REV.
C

AS3141™

STUD, STEPPED - 2.5 DIA ENGAGEMENT,
PD SHANK, UNS S66286
.3750-24 UNJF-3A X .3125-24 UNJF-3A

FIGURE 1 - STUD

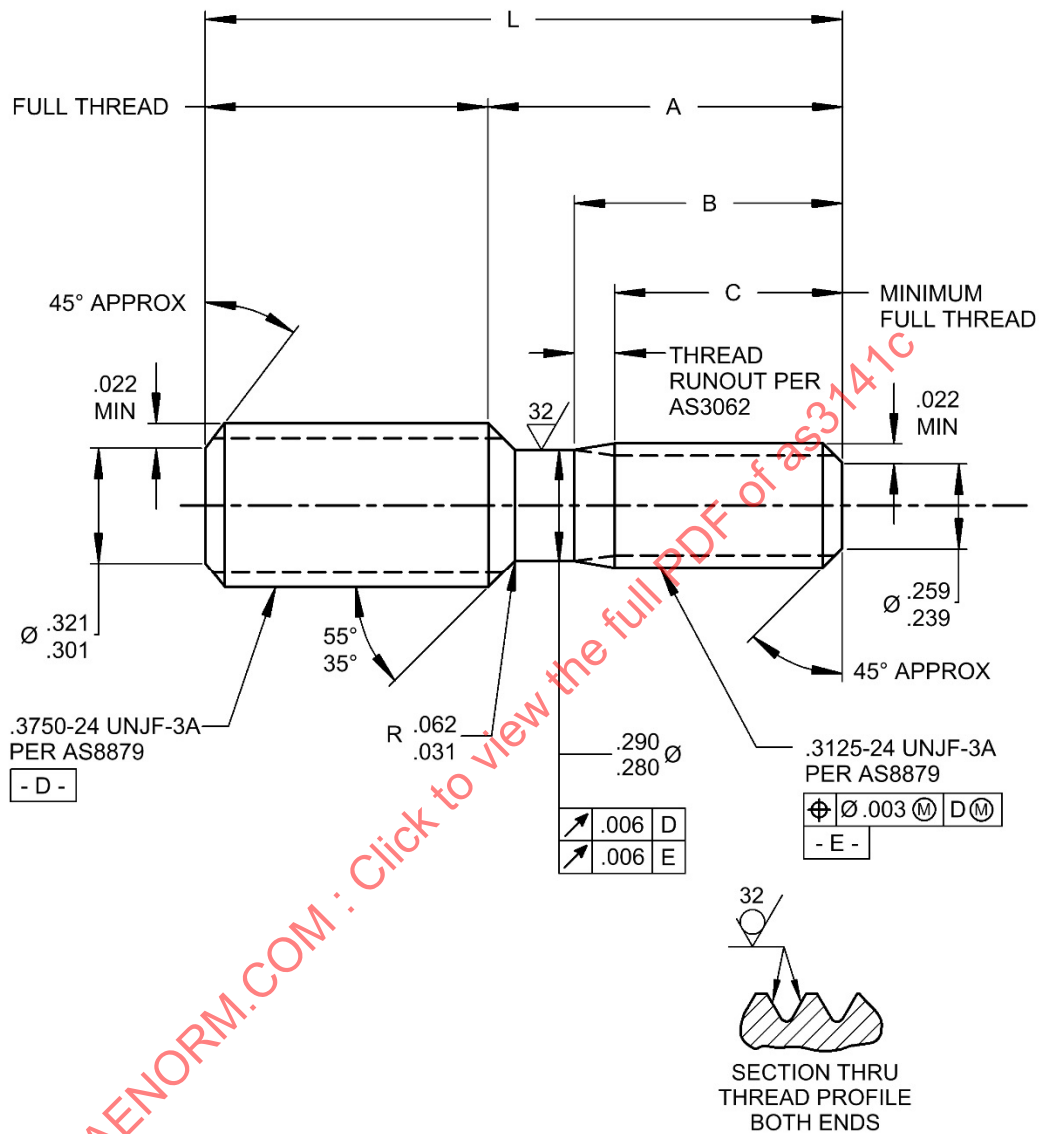
RELOCATE POSITION FEATURE CONTROL FRAME TO THREAD CALLOUT, REVISE LEAD THREAD CHAMFERS TO CONFORM TO AS1132, ADD AS3062 THREAD RUNOUT, ADD NEW NOTE FOR DISPOSITION OF EXISTING INVENTORY, GENERAL EDITORIAL UPDATES.
